# LM74700 Module test

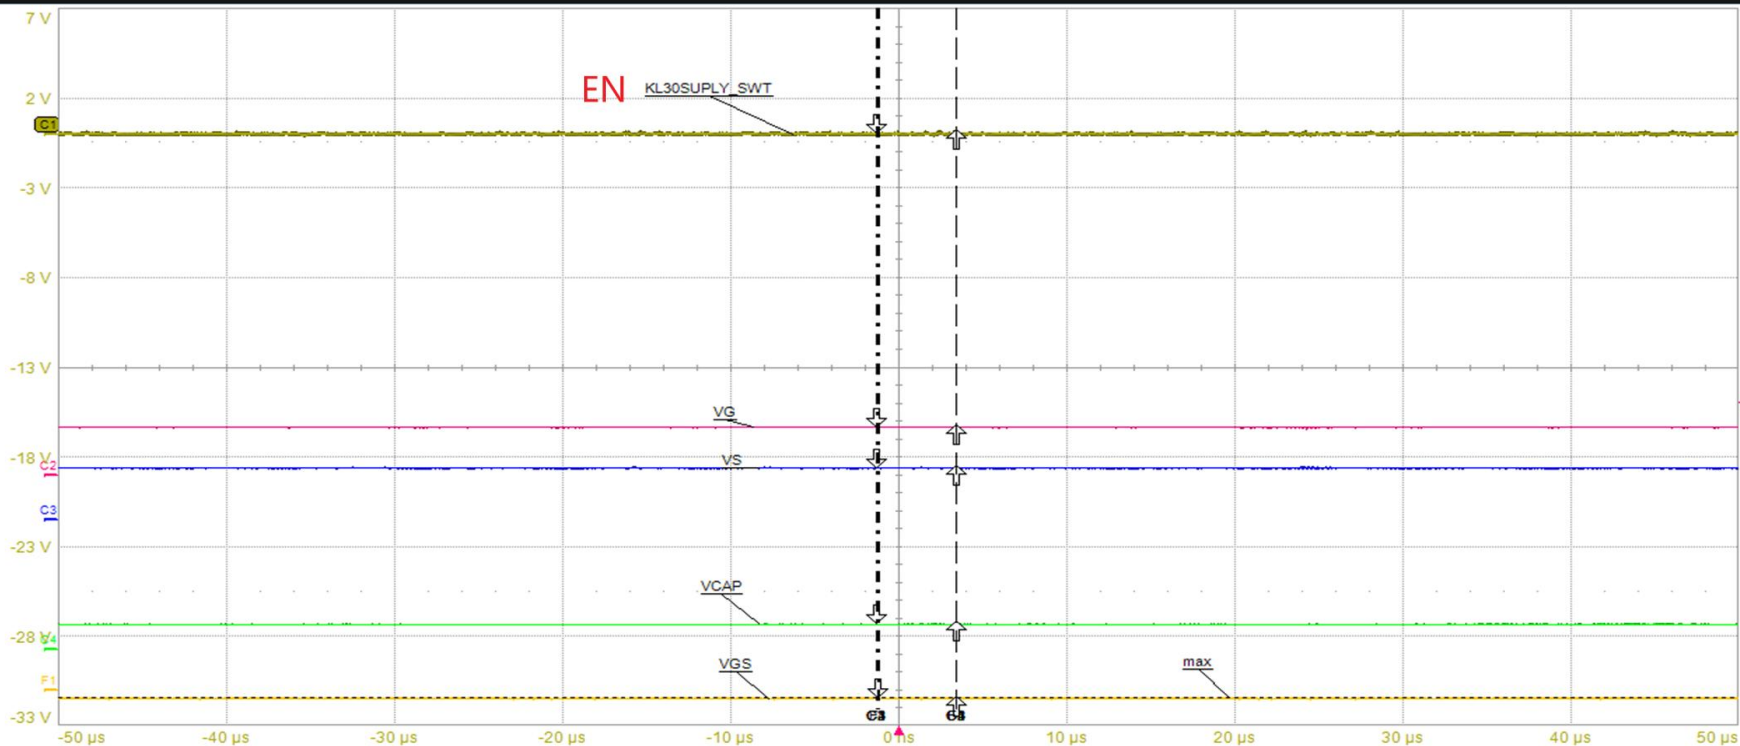
Maxrating Gate to anode is about : -0.3V~15V

Q1: -0.3V? How does this value come from? If the Gate-anode  $< -0.3V$ , what problem will it causes?

Q2: As the waveform shows when Vanode is 5.7V, EN=0, why the VGS is  $< -0.3V$ , about this what circuit or element should we do to solve this problem?

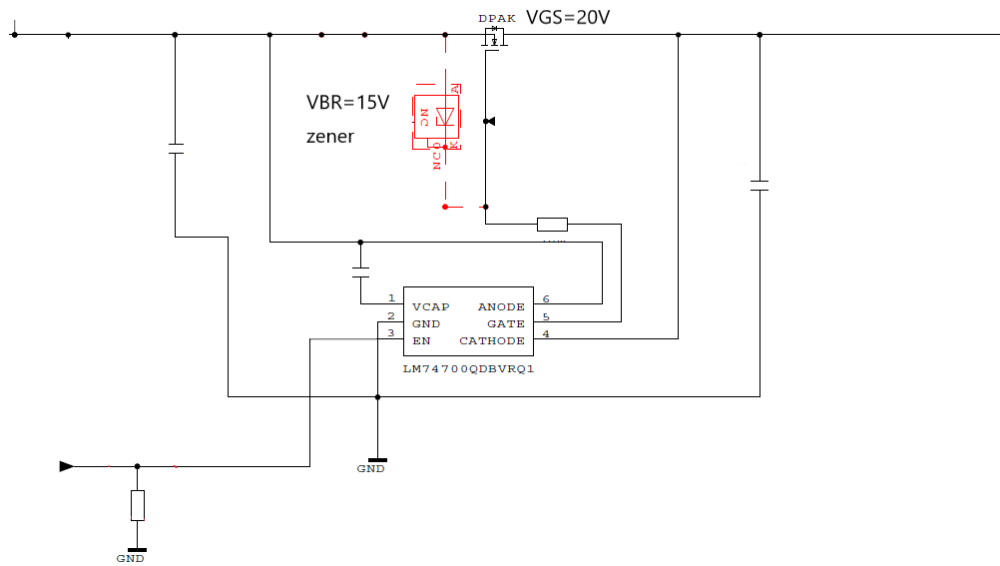
Q3:

Add one Zener which  $V_{BR} = 15V$ , please evaluate the feasibility of this circuit.
